# Work Order ID 62472

Item Name: Basket Hoop

DESIGN #	DRAWN BY CP	DART AEROSPACE LTD HAWKESBURY, ONTARIO, CANADA	
CHECKED #	APPROVED #	DRAWING NO. D3166	REV. A SHEET 1 OF 1
DATE 02.07.10		TITLE BASKET HOOP	SCALE NTS
A	02.07.10	NEW ISSUE	
A1	04.04.08	38+-1 WAS 36.0

DRAWING NO. D3166	TITLE BASKET HOOP	REV A1	DART AEROSPACE LTD ENGINEERING ORDER		D.E.O. NO. D3166-A-2	SHEET NO. 1 OF 1	SCALE NTS
DRAWN AJS	CHECKED L	MFG. APPR. A	APPROVED MD		DE APPR. H		
DATE 08.12.11	DATE 08.12.15	DATE 08/12/15	DATE 08/12/16		DATE 08.12.16

D3166-1 BASKET HOOP

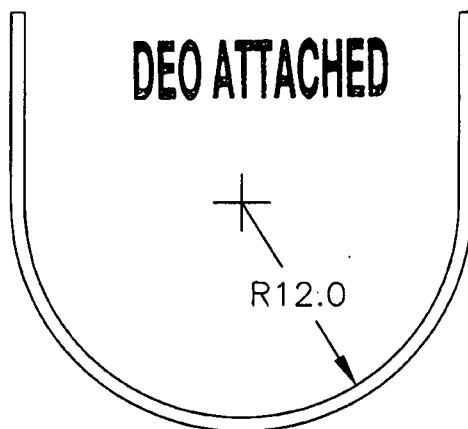
1) MODIFY MATERIAL NOTE FOR D3166-1 AS SHOWN:

IS:

1) MATERIAL: AISI 304/316 SS, 3/4 X 3/4 X 0.065 WALL SQUARE TUBING,  
60.00" LONG  
REF. DART SPEC M304TS0.750W.065

D3166-3 BASKET HOOP

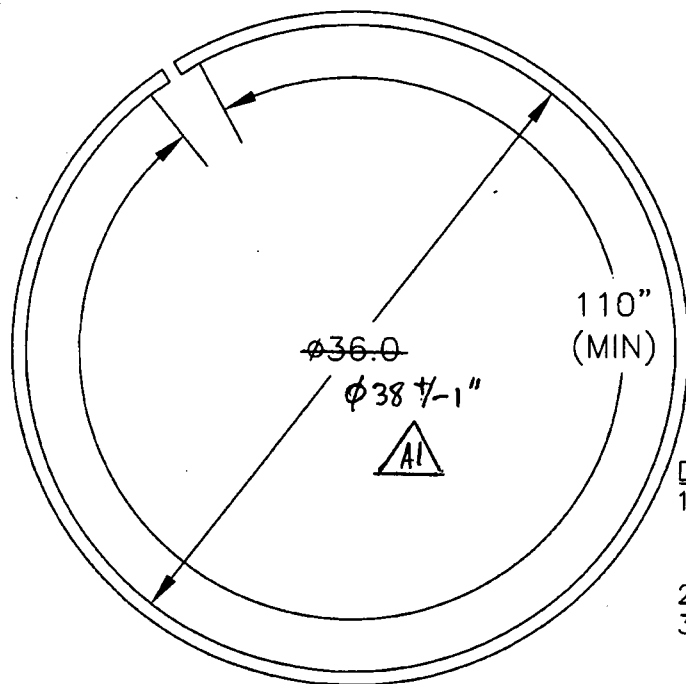
2) MODIFY MATERIAL NOTE FOR D3166-3 AS SHOWN:

IS:

1) MATERIAL: AISI 304/316 SS, 3/4 X 3/4 X 0.065 WALL SQUARE TUBING,  
120.00" LONG  
REF. DART SPEC M304TS0.750W.065
